Response to Submissions

6-30 Artarmon Road, Willoughby
Section 75W Modification to MP10_0198

Submitted to NSW Department of Planning and
Environment
On behalf of LEPC9 Pty Ltd

28 March 2018 | 15709

Figure 2 Final proposed master plan

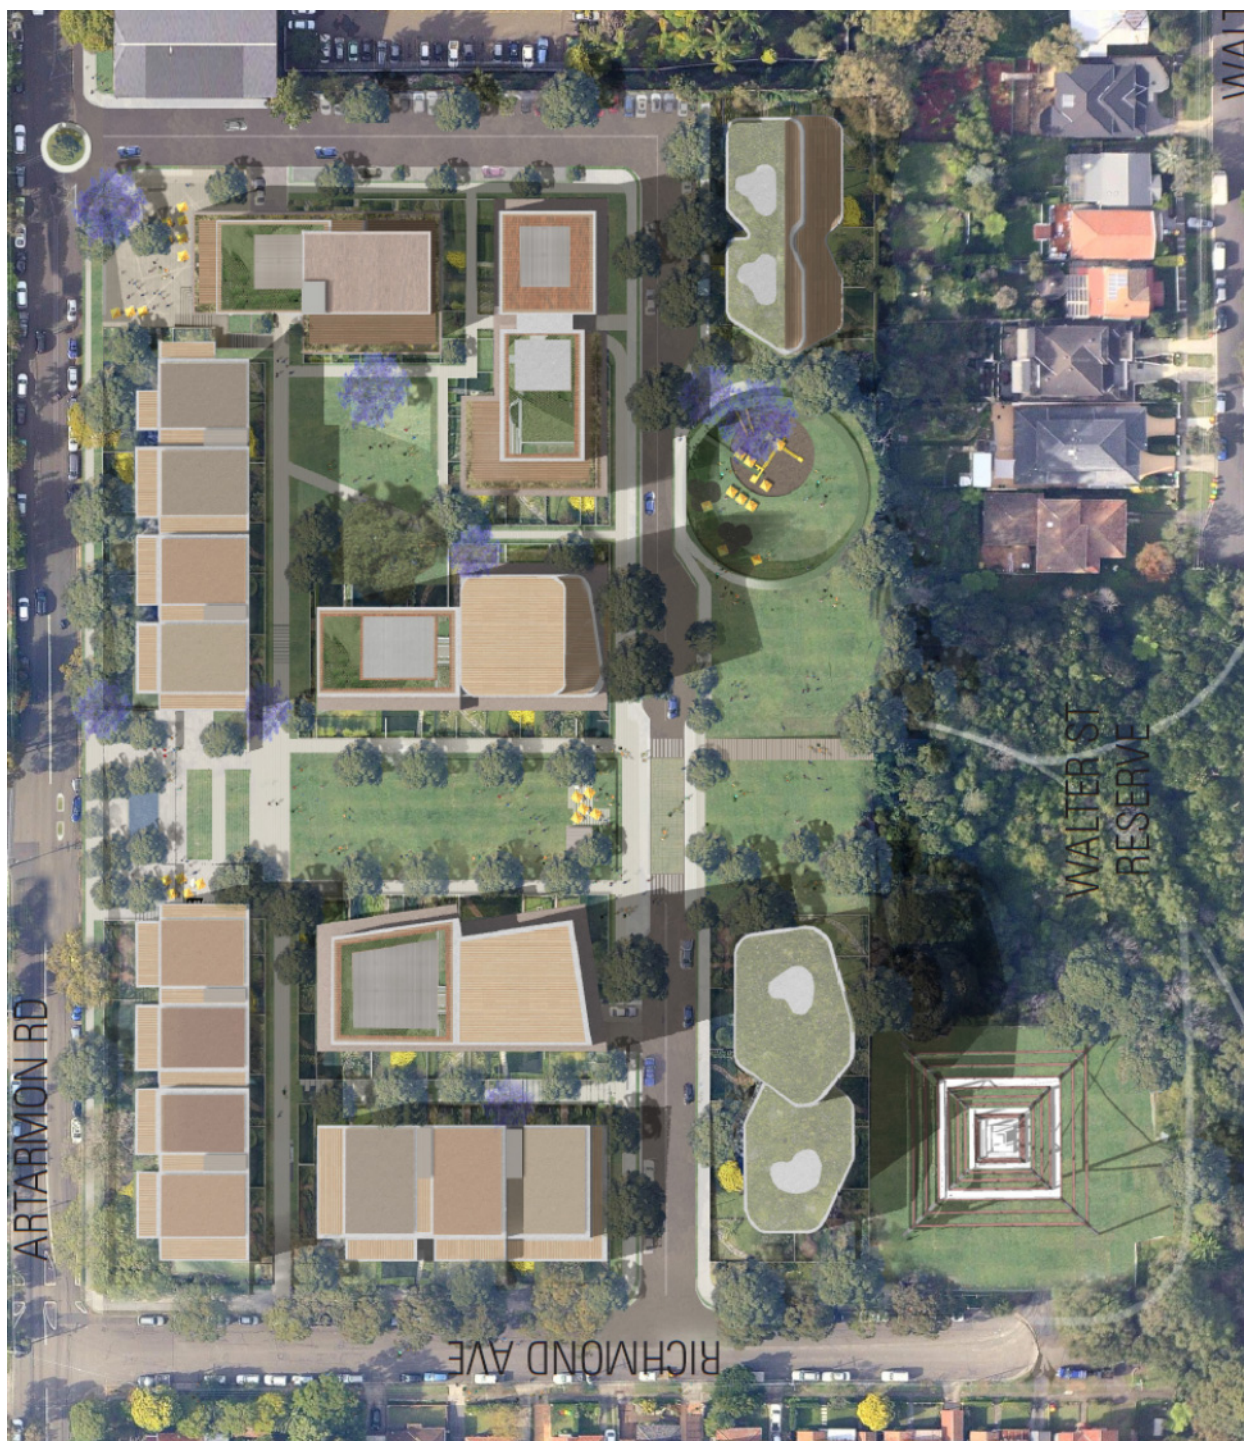
In response to issues raised by the Department, the Proponent and CHROFI have amended the master plan to set back proposed Buildings E and G from Scott Street in order to provide certainty that future development can achieve an appropriate landscaped setback, having regard to the existing and future anticipated roadway alignment and landscaped verge of Scott Street. This change has resulted in some minor additional adjustments to the Building G and F building envelopes for which Concept Approval is sought. No additional changes are proposed to the exhibited Modification Application. No changes are proposed to other aspects of the publicly exhibited Modification Application such as building heights or the quantum of dwellings or gross floor area proposed.

The only proposed amendment to exhibited Modification Application is a proposal to increase the setback of Buildings G and F from the Scott Street road reserve to require a minimum one metre setback from the property boundary. Providing this setback also entails minor consequent changes to these building envelopes. Amended maximum building envelope plans are included in the CHROFI Urban Design Response provided at **Attachment B**.

Figure 3 Indicative sections through 'sunken apartments' demonstrating suitable solar access and privacy

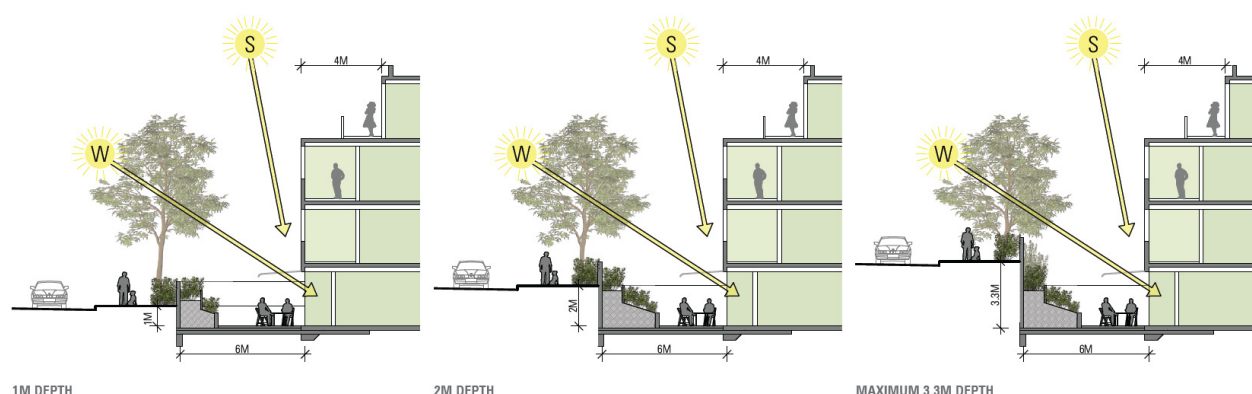
- As demonstrated in the CHROFI Urban Design Response, there are numerous examples of where 'sunken apartments' have been delivered in Sydney with good amenity and urban design outcomes. Indicative cross-sections of potential apartments (**Figure 3**) within the site with frontages to Artarmon Road and Richmond Avenue demonstrate that a detailed design outcome is readily achievable that attains adequate direct sunlight, suitable dimensions and appropriate visual privacy. Accordingly, the Department may be satisfied that detailed building design for these apartments can achieve the relevant urban design and residential amenity requirements.

Figure 4 Scott Street section illustrating lot boundaries (red), existing carriageway and future landscaping

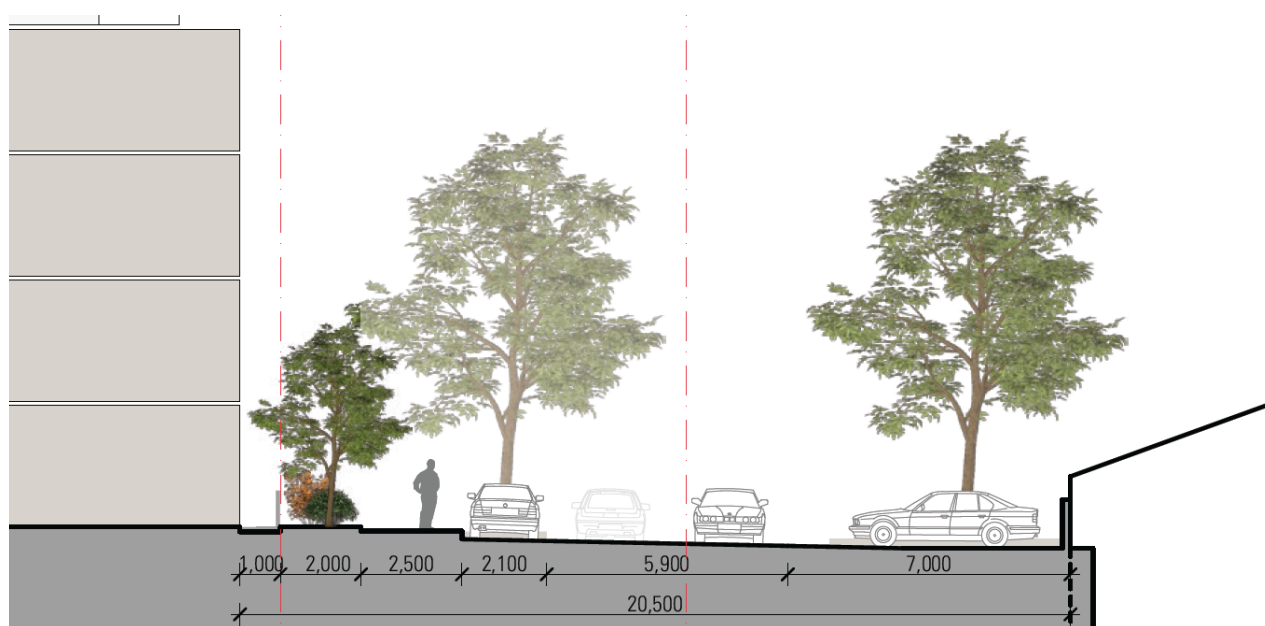
4.2.2 Scott Street building setbacks

As outlined in **Section 3.1**, the proposed building envelopes contained in the CHROFI master plan have been revised to provide a one metre setback between the Scott Street road reserve and the eastern edge of the maximum building envelope for Buildings G and F.

The increased setback to the property boundary will result in a total setback of 5.5m from the kerbside parking lane and 7.6m from the carriageway (existing). No change is proposed to the location or alignment of the existing Scott Street carriageway as part of this Modification Application, and Council has not identified any works to Scott Street as part of its infrastructure schedule of works that would alter the existing alignment. As noted in **Section 4.1.2** the consent authority for future Development Applications is able to require improvements to the road reserve to ensure a high-quality street environment and landscaped verge that are consistent with the Concept Approval.

As demonstrated in Sections 3.15-3.16 of CHROFI Urban Design Response (**Attachment B**), the proposed setback provides adequate space for a generous landscaped verge to Scott Street with landscaping, large tree planting and pedestrian footpaths (**Figure 4**).
